COUNTY OF SAN MATEO  
PLANNING AND BUILDING DEPARTMENT

**RECOMMENDED FINDINGS AND CONDITIONS OF APPROVAL**

Permit File Number: PLN 1999-00215

**SUBJECT:** EXECUTIVE SUMMARY: Consideration of a Coastside Design Review Permit, pursuant to Sections 6565.4 (Coastal) and 6328.5 of the County Zoning Regulations as they existed in 1999, to construct a new 2,982 sq. ft. single-family residence and 400 sq. ft. detached garage on a 5,000 sq. ft. parcel located on Second Street, in the unincorporated Montara area of the County. (Appeal from decision of the Planning Commission denying the Design Review). This project is not appealable to the California Coastal Commission.

## INTERIOR LOT HOUSE (APN 200)

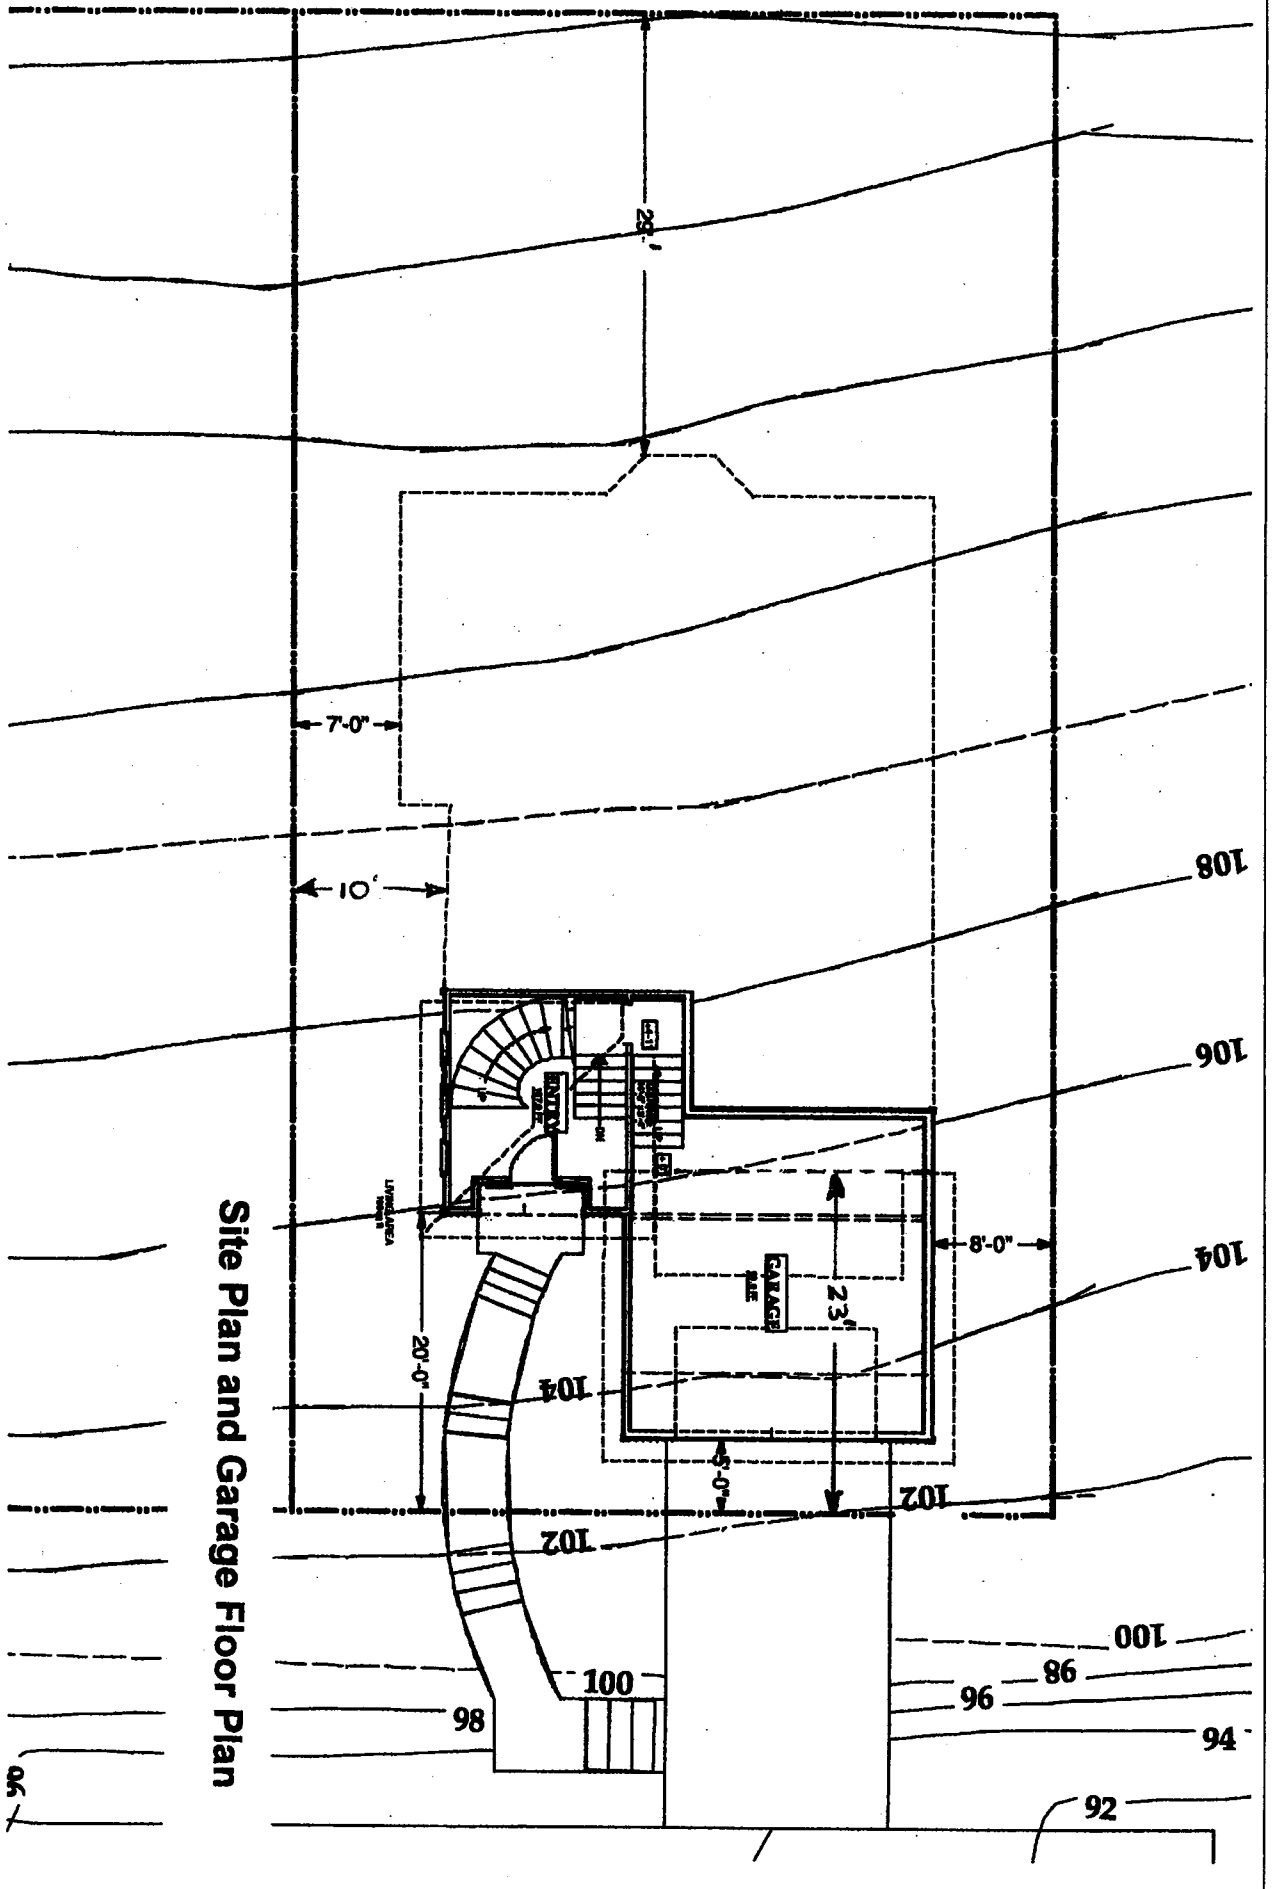
Modifications to plans made pursuant to directives from San Mateo County Board of Supervisors at hearing held on 3/31/09 :

- 1.) Building now has Story setbacks established at *each* and every successively higher story.
- 2.) Design Form more closely mimics the natural terrain of the site with both roof-line as well as floor-line.

- 3.) Building Lowered into the Ground.
- 4.) Reduction of Building Mass *via* :
  - a.) Elimination of both upper and lower story covered deck elements at most prominent part of building.

- b.) Elimination of two-story single-plane massing at most prominent part of building.
  - c.) Introduction of 5 foot setback of uppermost story at most prominent part of building.

- f.) House Plans now contain three (3) separate levels – following the rise in terrain – in addition to Garage level.
  - g.) Introduction of sloping roof line following the rise in terrain from front to rear above both separate entry element as well as second story element at front.

- i.) Introduction of recessed area into upper-story at rear of building – creating additional articulation as well as reducing upper-story massing.
  - j.) Reduction in scale of Entry Element in relation to building and prominence of overall mass; Introduction of recessed detail eliminating need for additional canopy & mass, as well as creating visual interest.

Exhibit A.2

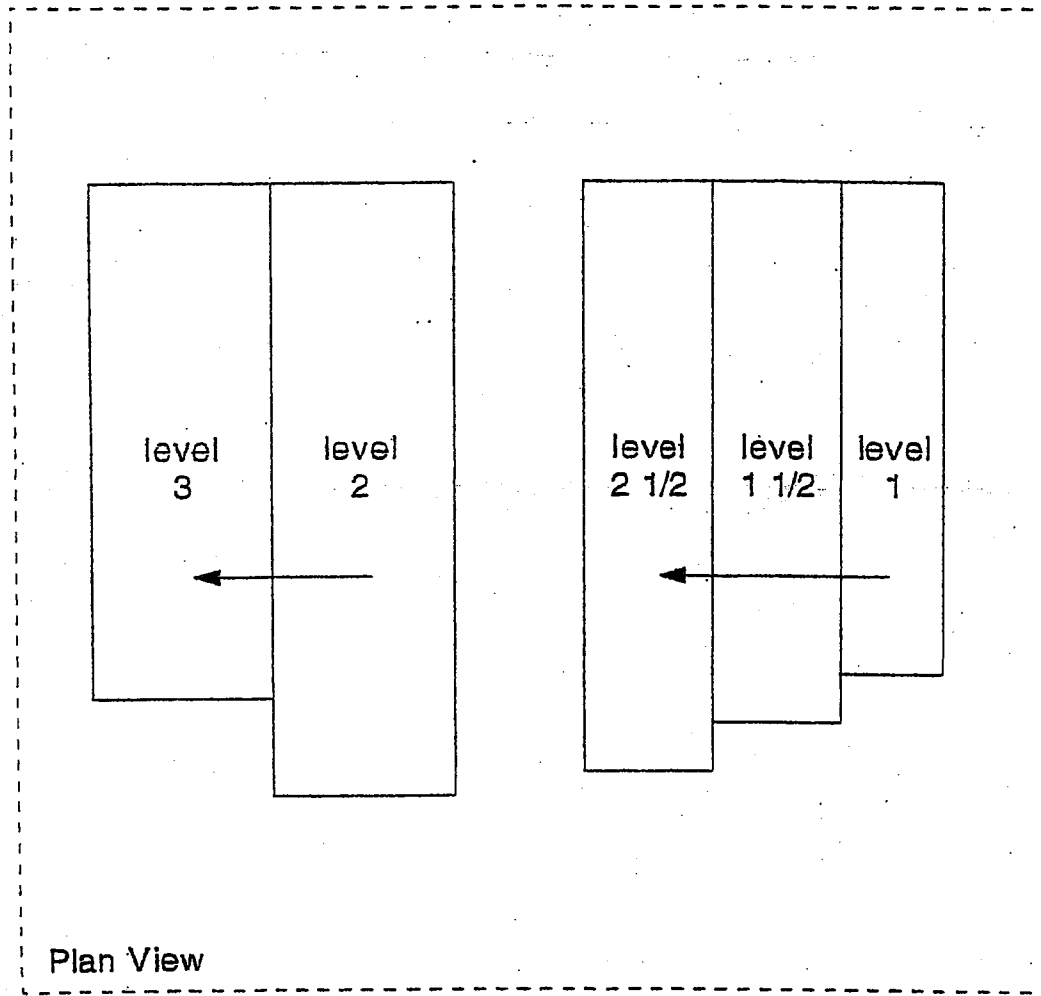
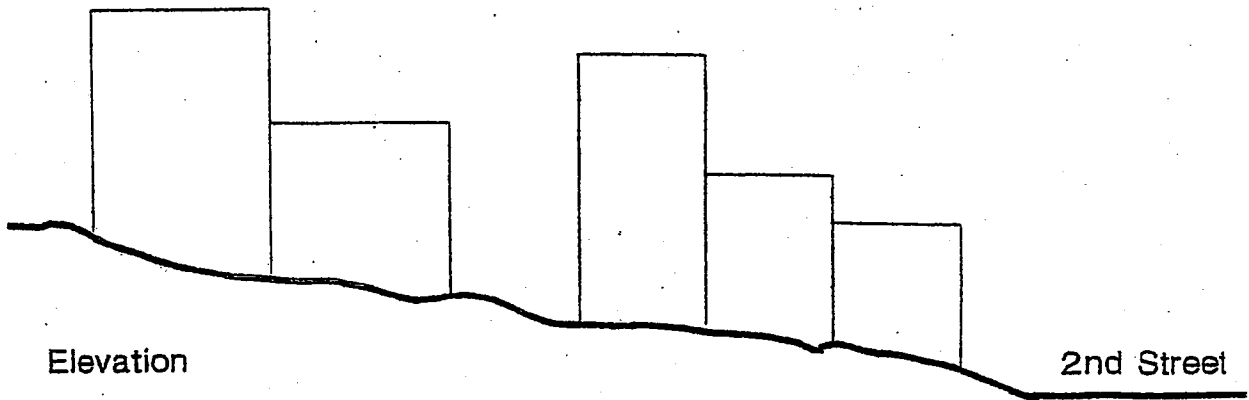
Schematic proposal for structure to follow grade of land to reduce appearance of mass and height. Structures in E-W orientation.

*Recommended  
re-orientation*
